Memorandum

To:	Mr. Greg Wands Chair, Ashland Conservation Commission	Project Number:	24142
From:	Will Park, PE	Date:	1/13/2025
Project Name:	61 Waverly Street – Notice of Intent		
RE:	Response to GCG Associates Stormwater Peer Review Comments		
Distribution:	Israel Lopez - The Gutierrez Company, Mark Arnold - Goddard Consulting, Luke Norton & Corinne Disenhof - Sanborn Head & Associates

Attachment 4: Proposed Project Site Disturbance - Alternative Scenario

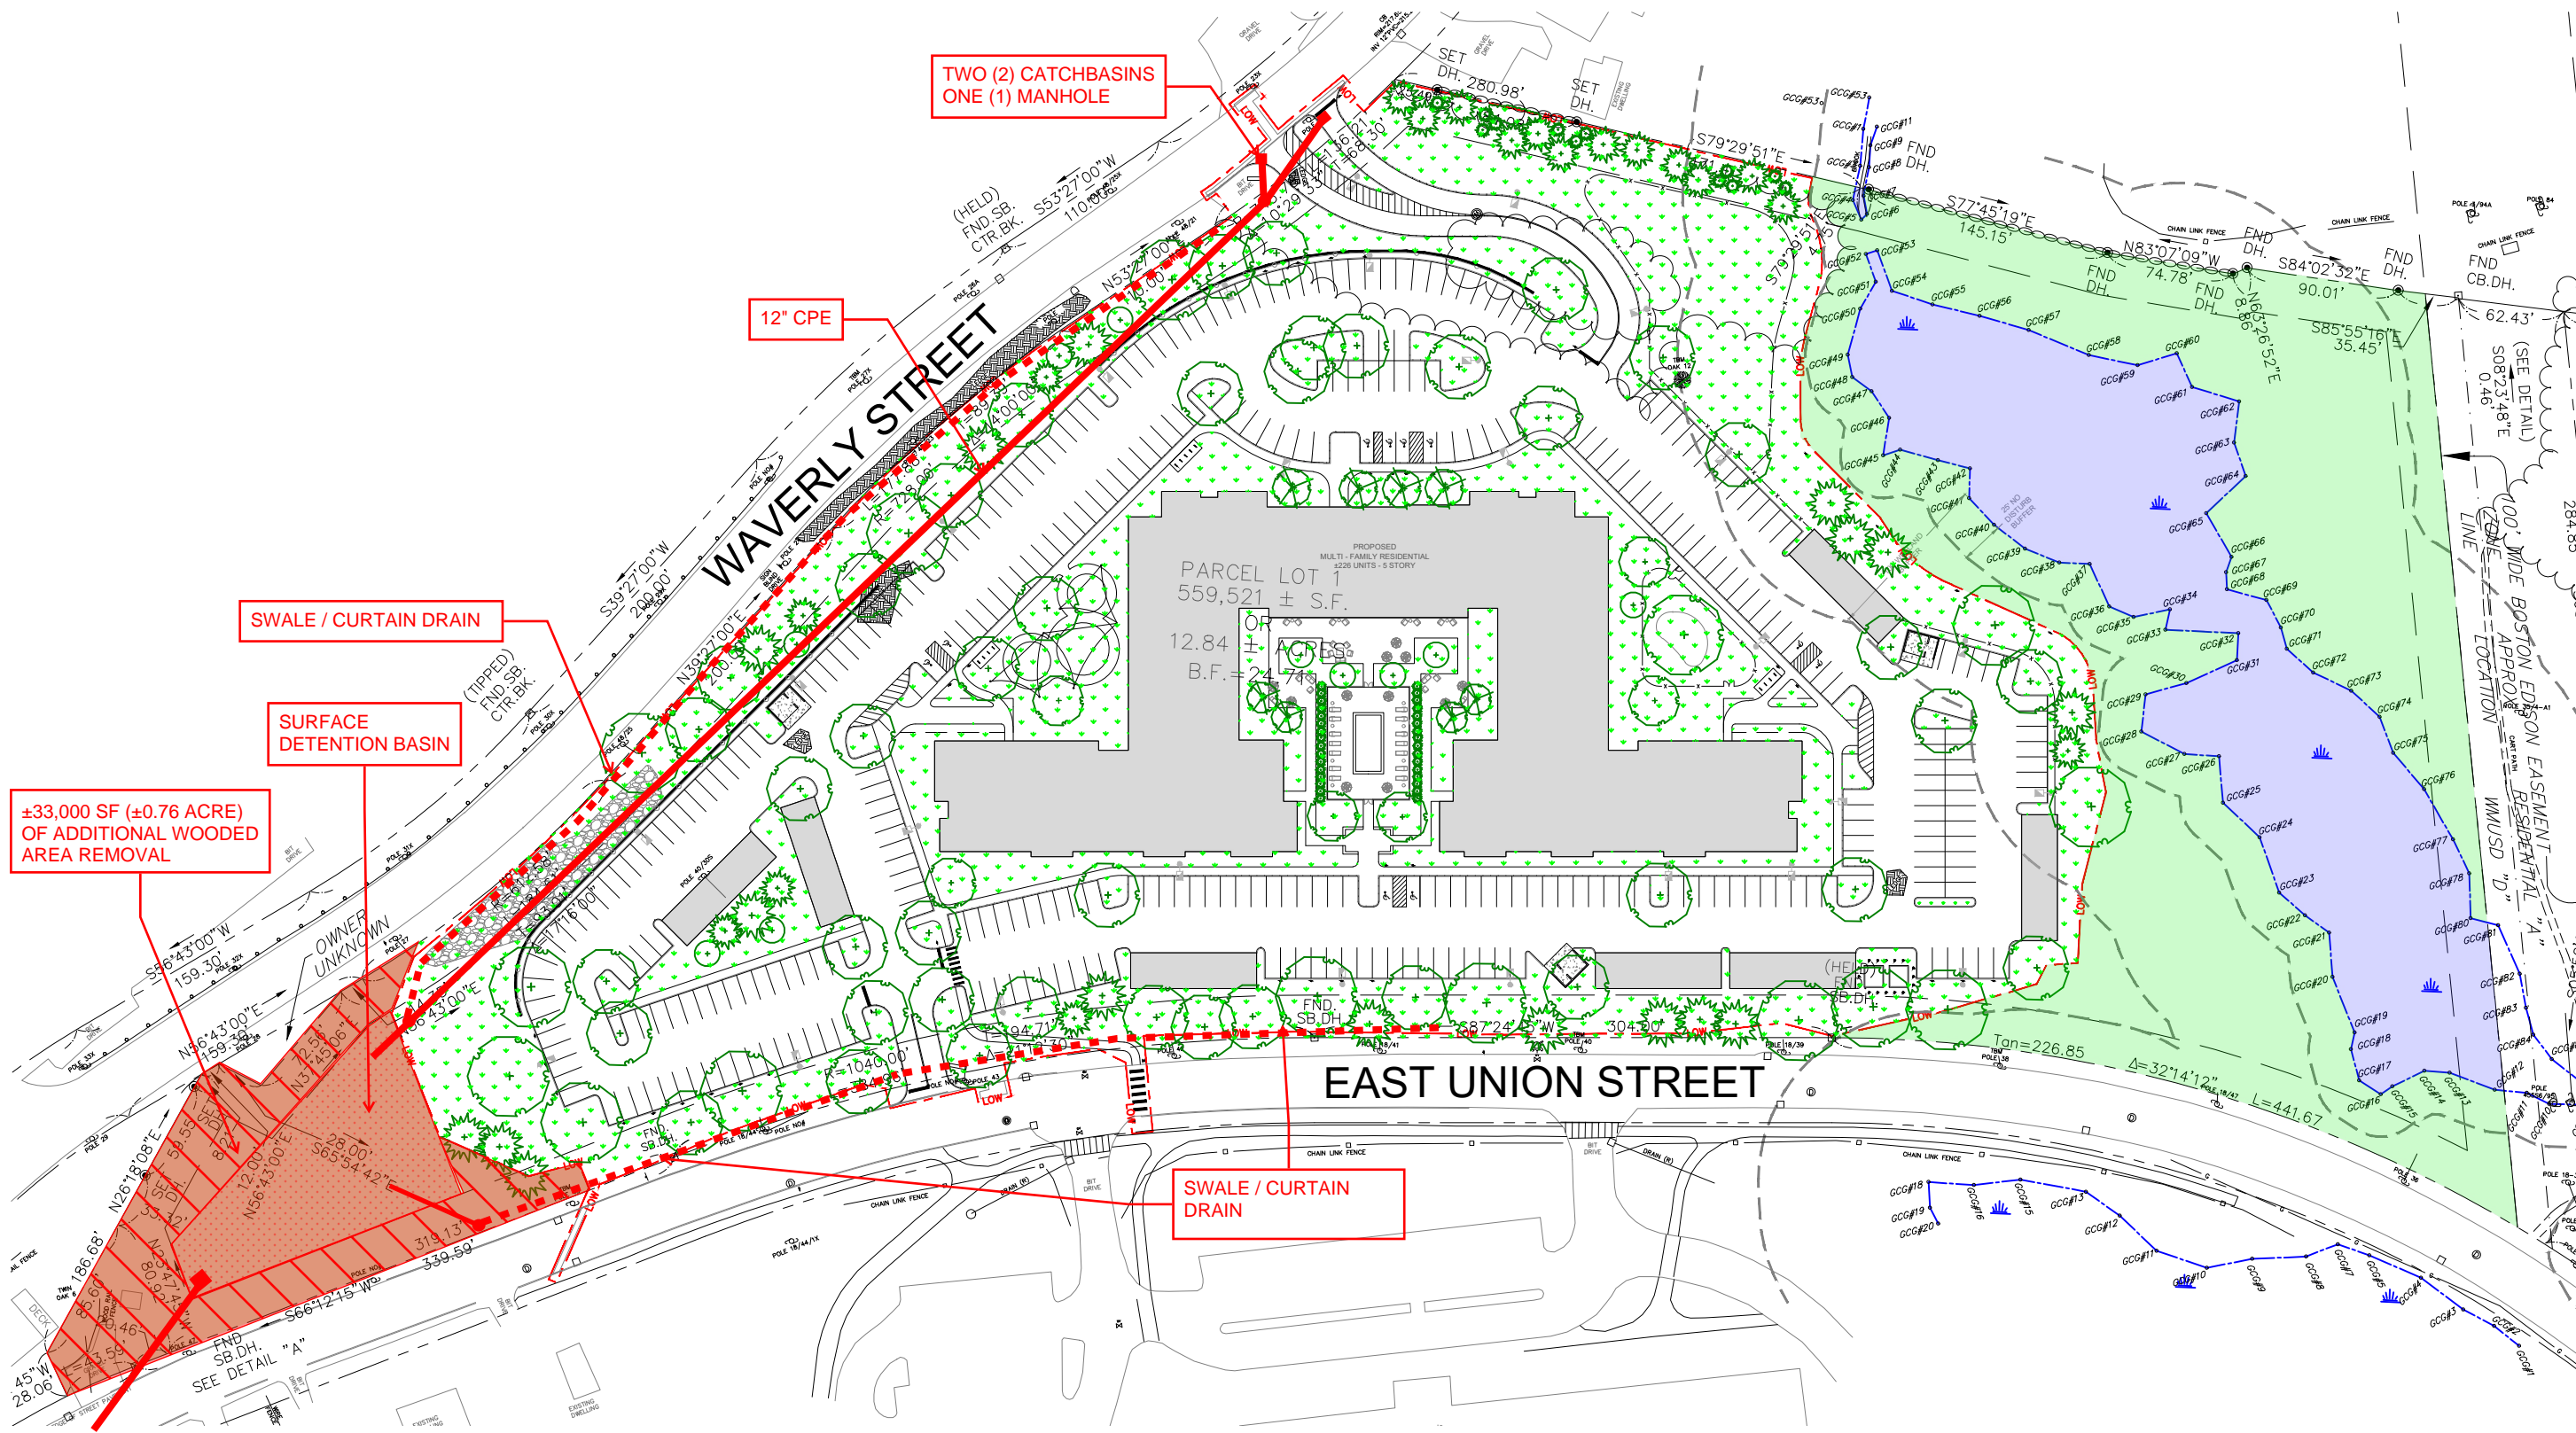
The de minimus combined increase of 0.15 CFS to DP-4 and DP-5 in the 10-year storm event is attributable to the narrow perimeter subcatchment areas that cannot be physically collected, detained, and treated¹ without causing significant and unnecessary disturbance to a major portion of the site that is intended to remain undisturbed. For illustration purposes only, we have modeled the area of disturbance that would need to be cleared in order to install another surface basin to force the HydroCAD model to output a 0.00 increase to these two DPs. Attachment 3 shows the project disturbance as currently proposed. As shown in Attachment 4, the entire wooded western portion of the site would need to be clear cut and, a drainage pipe would need to be blasted through the site for a length of over 800 linear feet to detain the 0.15 CFS. This level of disturbance is neither beneficial to the site nor in furtherance of any WPA interests.

±33,000 SF (±0.76 ACRE)
OF ADDITIONAL WOODED
AREA REMOVAL
